Subject: Final Report - DER 83-25
A 50.55(e) Report Relating To Instrumentation Tubing Does Not
Have A Boundary Class Break As Required
File: 83-019-026; D.4.33.2

FINAL REPORT - DER 83-34

PVNGS UNITS 1, 2 and 3

ASME SECTION III
JURISDICTIONAL BOUNDARIES FOR
INSTRUMENT TUBING LINES

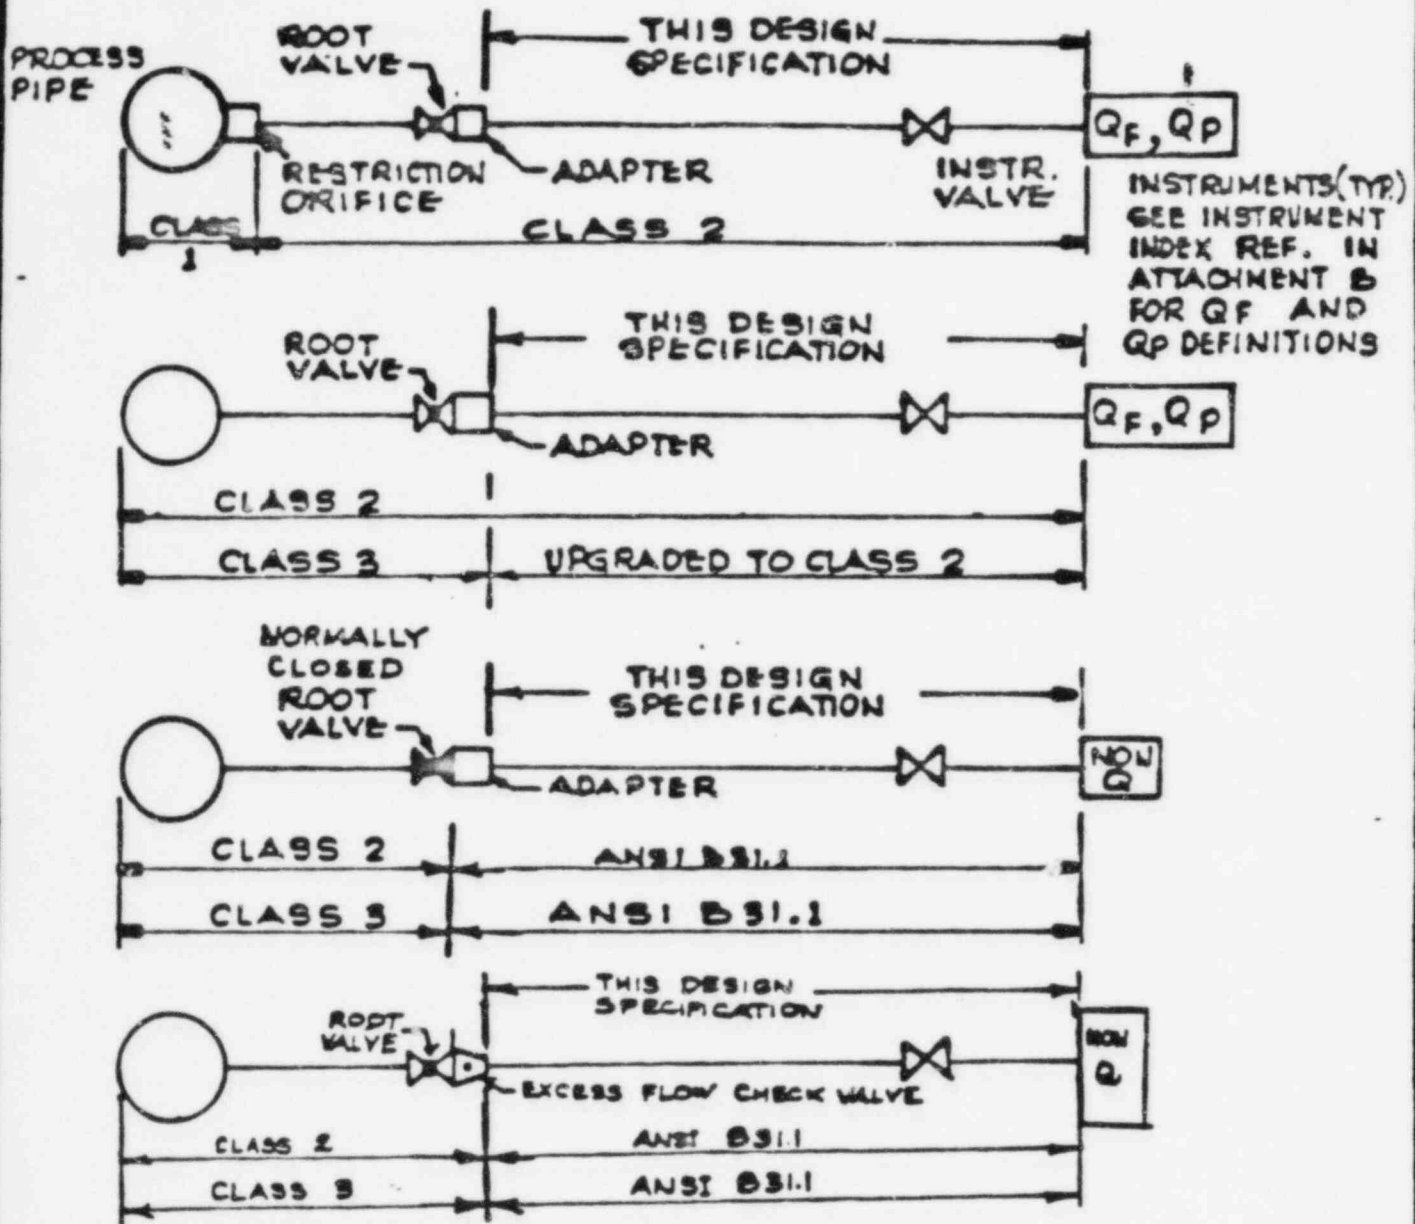
Specification 13-JM-715 establishes design specifications for nuclear service instrument lines and supports. Per the bottom two figures of specification Attachment A-2-Sheet-1, Revision 3 (see DER Attachment 1), a class break consisting of either a normally closed root valve or an excess flow check valve is required for instrument tubing lines connecting Quality Class Non-Q instruments to ASME Class 2 or 3 process lines. Contrary to this requirement, a review of the Project Instrument Index (Bechtel Dwg. 13-J-ZZI-001) and associated Piping and Instrumentation Diagrams showed Quality Class Non-Q instruments on ASME Class 2 and 3 process lines with no automatic shutoff device installed. A complete list of these occurrences, derived via cross-checking of the Index and the Construction Information Package, is documented in Block 12 of Nonconformance Report JX-907 (DER Attachment 2).

ASME SECTION III
JURISDICTIONAL BOUNDARIES FOR
INSTRUMENT TUBING LINES

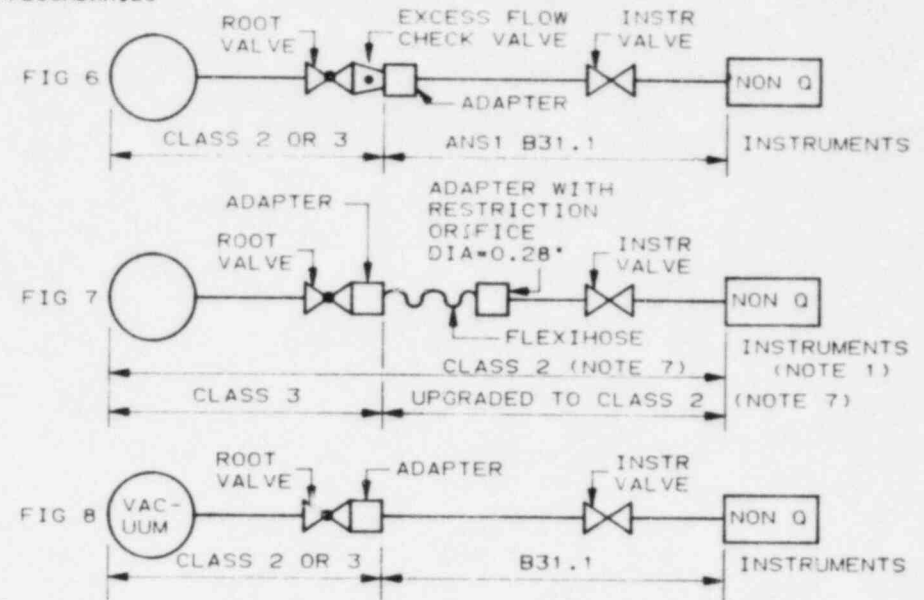
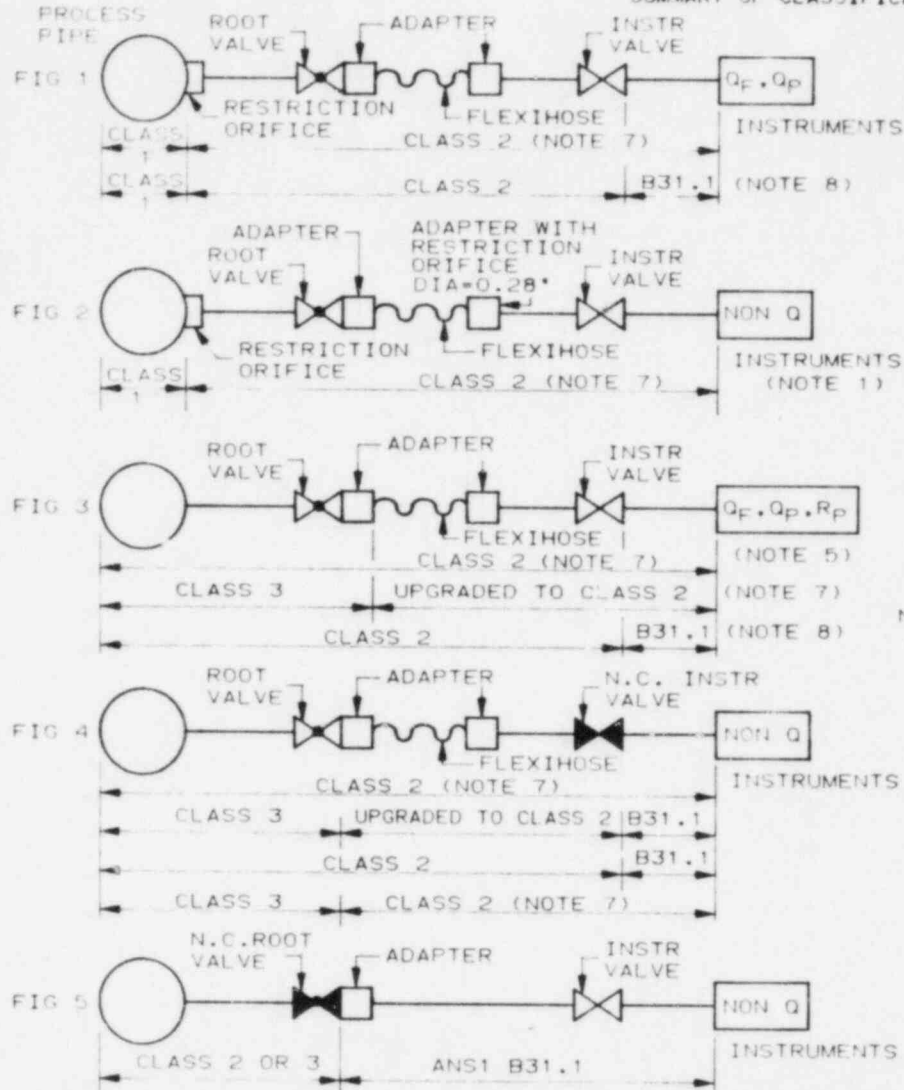
- 1) Specification Change Notices 3432 and 3451 have been issued against Specification 13-JM-715, revising Attachment A-2-Sheet-1 to Revision 4, which redefines the requirements for Quality Class Non-Q instruments on ASME Class 2 and 3 process lines. The revised specification Attachment A-2-Sheet-1, Revision 4 is included in this Deficiency Evaluation Report as (DER Attachment 3) for information.

1. CALC 13-JC-ZZ-009 SHOWS THAT FOR SPECIFIC INSTALLATIONS, MAKE-UP CAPACITY IS GREATER THAN FLUID LOSS DUE TO A LINE BREAK.
2. EXCESS FLOW CHECK VALVES FURNISHED UNDER 13-JM-705 ARE CLASS 2.
3. WELDING OF WELD TO TUBE ADAPTERS OR EXCESS FLOW CHECK VALVES TO NORMALLY OPEN ROOT VALVE SHALL BE PER ASME III.
4. WELD TO TUBE ADAPTERS FURNISHED UNDER 13-JM-710B ARE CLASS 2.
5. R_P INSTRUMENTS MOUNTED AS SEISMIC CAT 1 OR 9.
6. FIG 1 & 3 MAY BE FITTED WITH A CLASS 2 CONDENSATE POT BETWEEN ROOT VALVE & FLEXIHOSE AS REQUIRED.
7. FACTORY HYDROSTATIC TESTING SHALL BE ACCEPTABLE IN LIEU OF IN SITU TESTING FOR THE CLASS 2 TUBING DOWNSTREAM OF THE INSTRUMENT VALVE.
8. TUBING AND VALVE DOWNSTREAM OF INSTRUMENT VALVE SHALL BE PER B31.1 FOR CE FURNISHED INSTRUMENTS MOUNTED IN CE FURNISHED RACKS.
